National Committee on Uniform Traffic Control Devices

9
10 **TECHNICAL COMMITTEE:** Bicycle Technical Committee

11
12 **TOPIC:** Two-Stage-Turn Queuing Box

RECOMMENDED MUTCD PROVISIONS/ REVISIONS:

1 **Figure 9C-x. Example of a Two-Stage Turn Queueing Box**

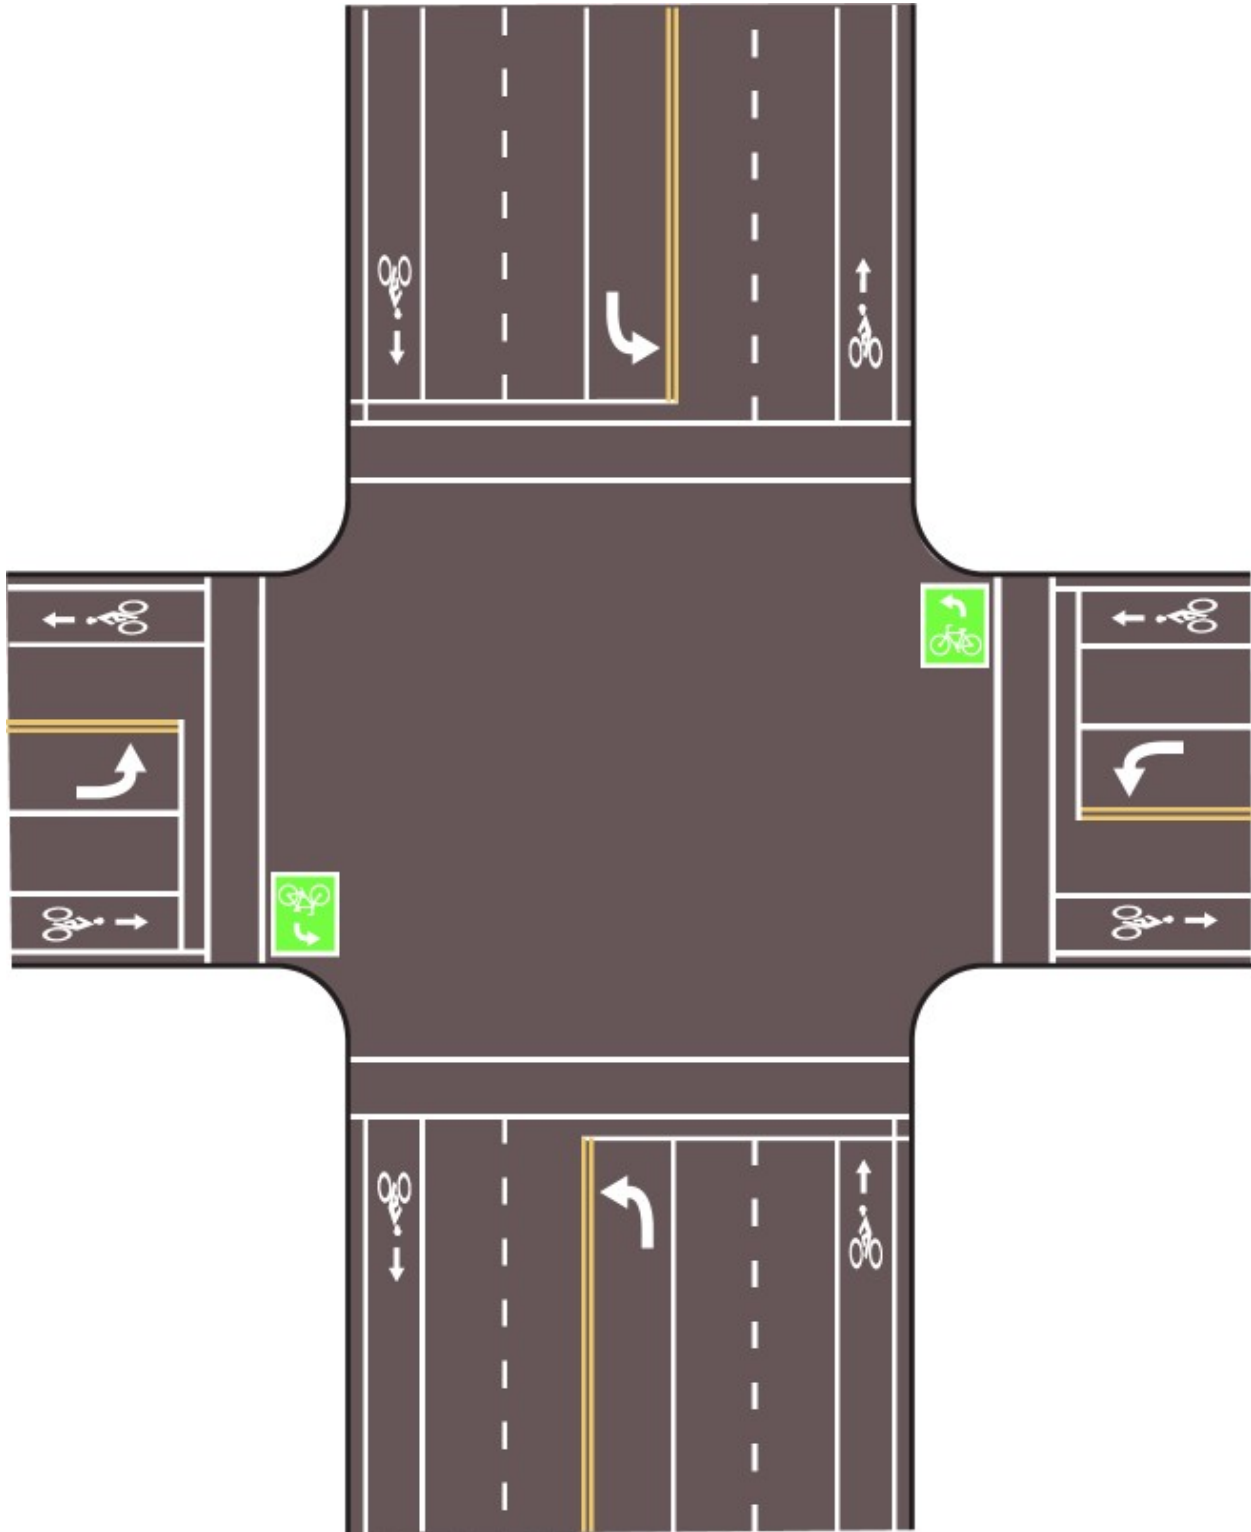
Section 9C.XX Two-Stage Turn Queuing Box

01 A two-stage turn queuing box should be located outside of the path of turning traffic. A No Turn on Red (R10-11) sign should be installed where a two-stage turn queuing box is not located outside the path of right turning traffic.

02 A two-stage turn queuing box should be located downstream of the crosswalk and downstream of the stop line.

03 A bicycle symbol shall be placed in the two-stage turn queuing box oriented in the direction in which the bicyclists enter the box, along with an arrow showing the direction of turn.

04 Passive detection of bicycles in the two-stage turn queuing box shall be provided if detection is required to actuate the signal which allows bicyclists to cross.

05 A two-stage turn queuing box is most commonly used for left turns, but it may be used for right turns from the left side of a one-way roadway.

06 Green colored pavement may be used within the two-stage turn queuing box.
